Town of Leicester PLANNING BOARD

PLANNING BOARD AGENDA Tuesday April 6, 2021 @ 7:00PM *ONLINE MEETING ONLY*

Memorandum

Re: 124 Green Street
Marijuana Outdoor Cultivator
Special Permit/Site Plan Review
Third Review

SITE PLAN

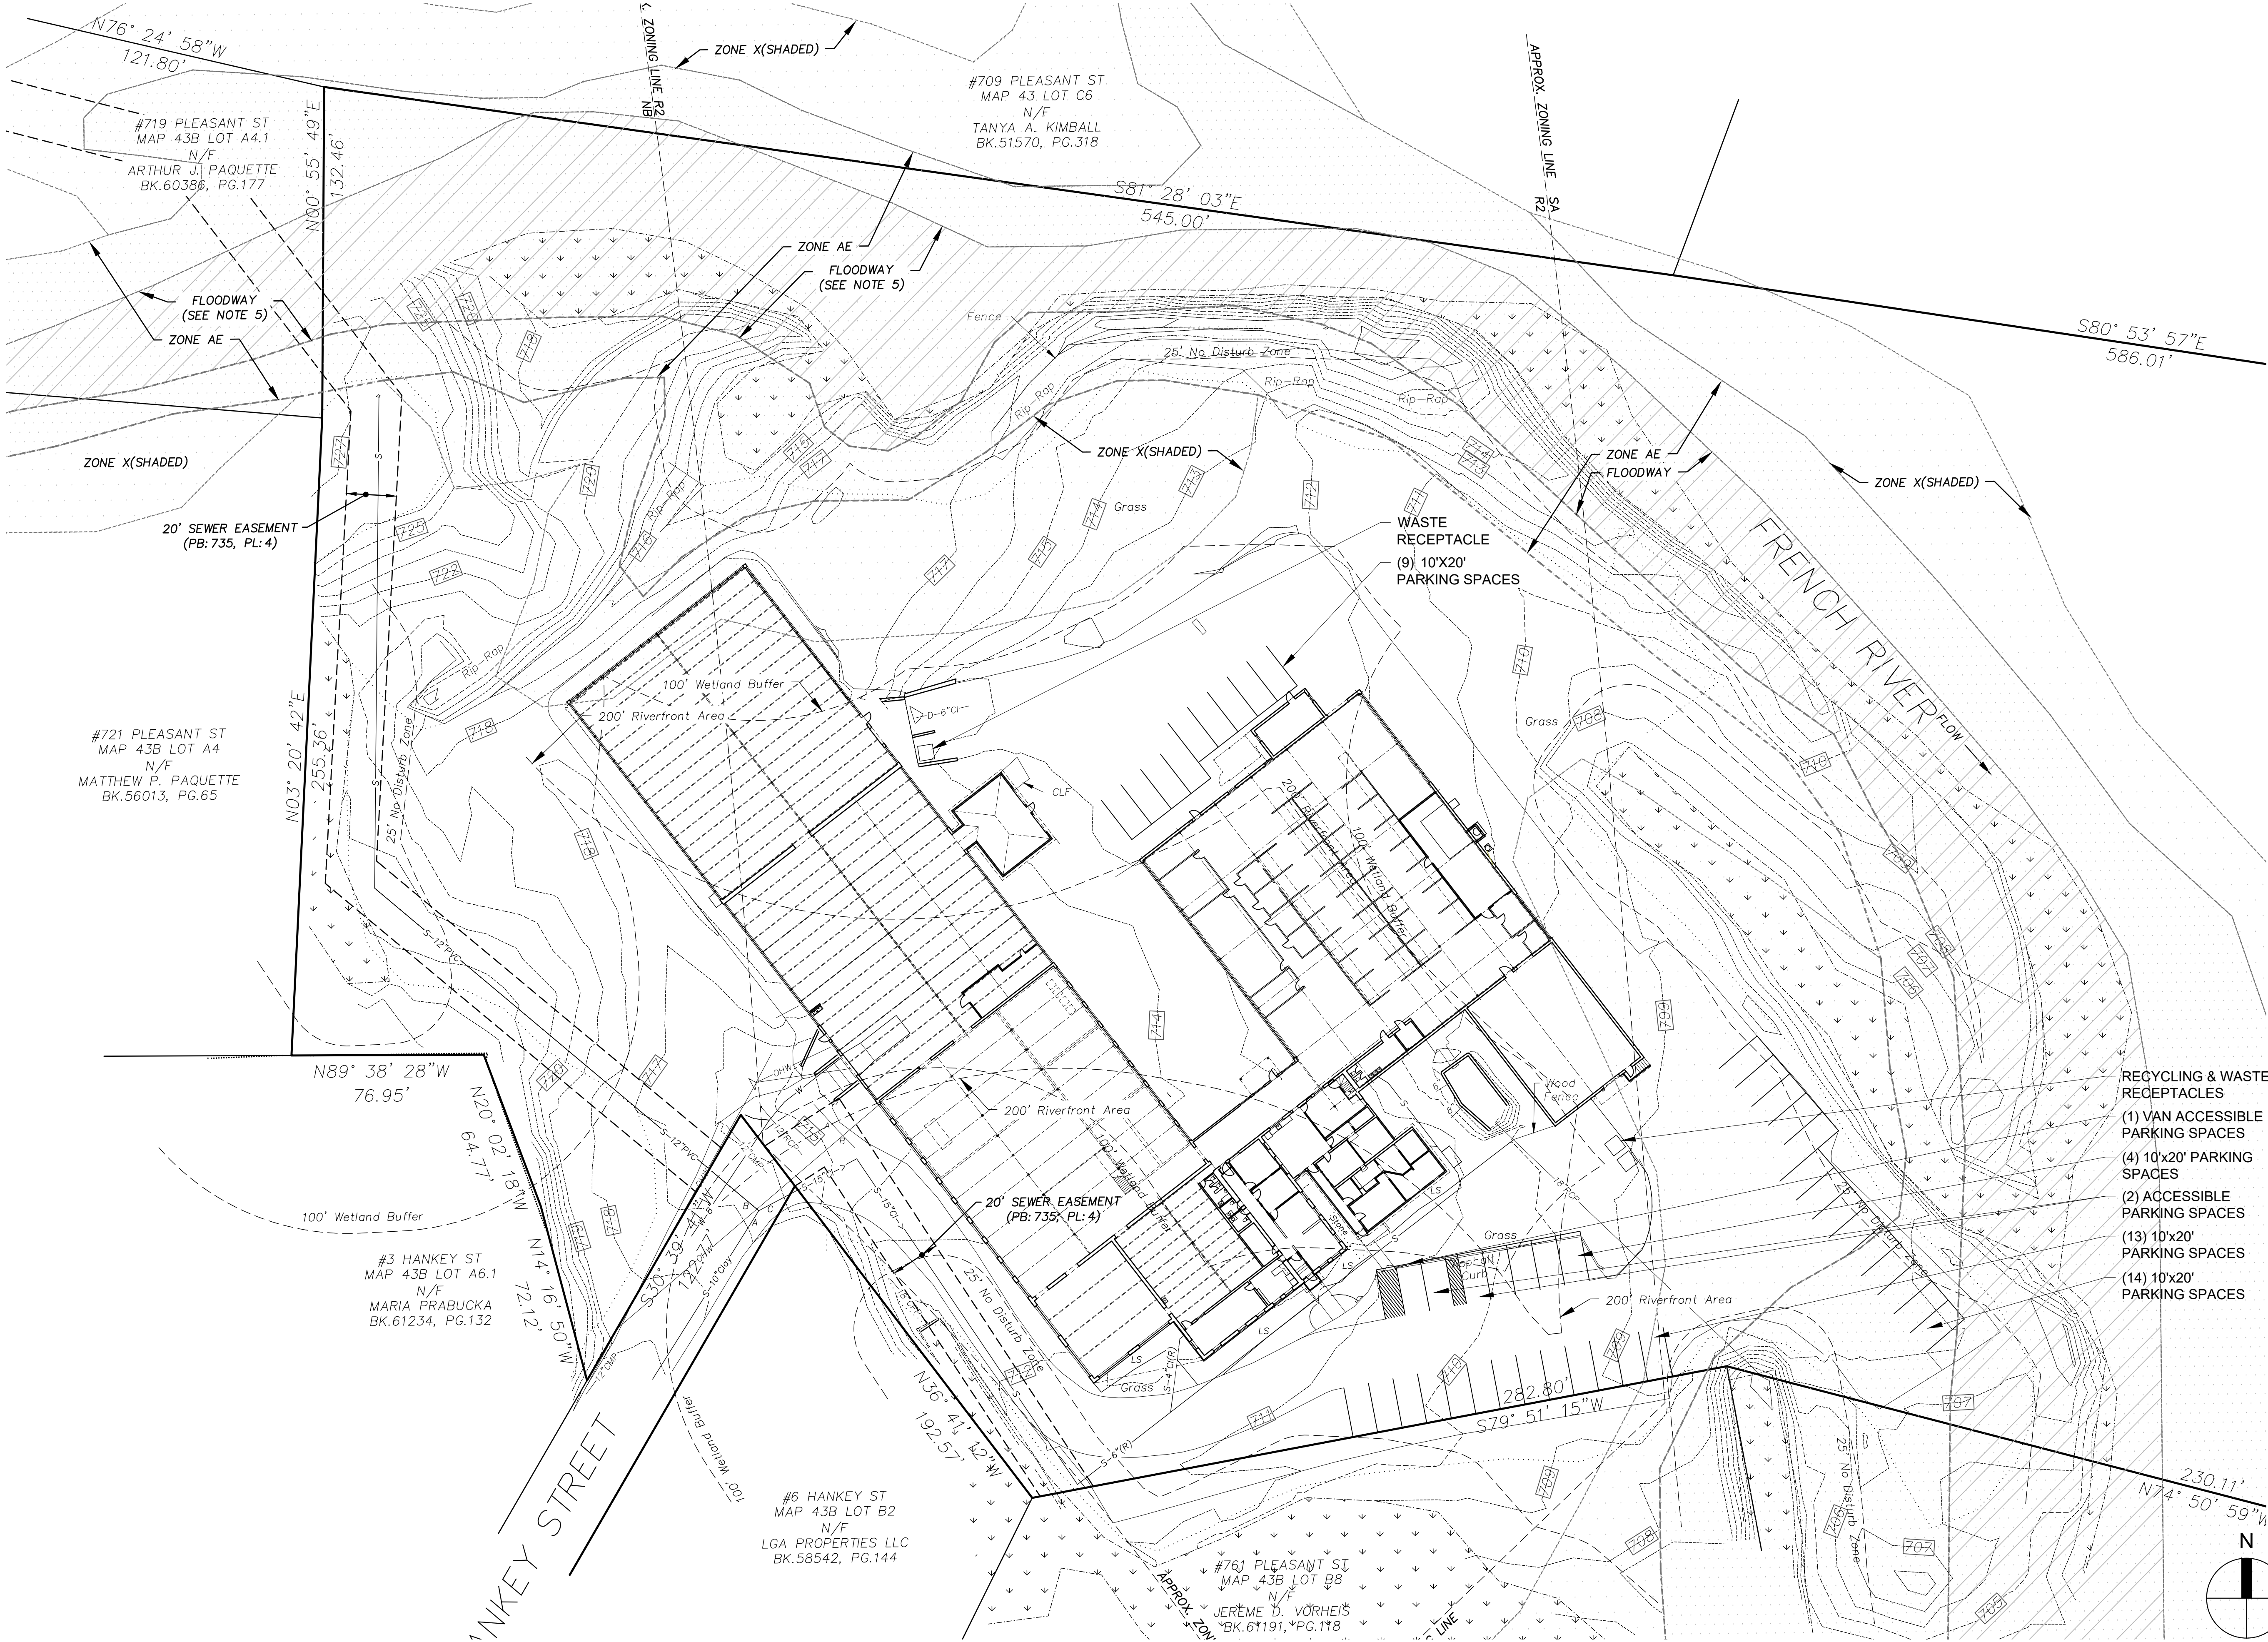
- The Site Plan (Sheet A1.00) shows that the parking spaces on the south side of the property are encroaching on the neighboring property. Is this accurate? Also, is this existing or proposed layout?
- Where is the overflow parking mentioned in the narrative as being shown on Exhibit F?
I don't see overflow parking on Exhibit F.
- What other uses are operating or planned for the building besides the activities described in your application? (I'm only aware of Valenti Precision) Describe the parking needs of other uses.
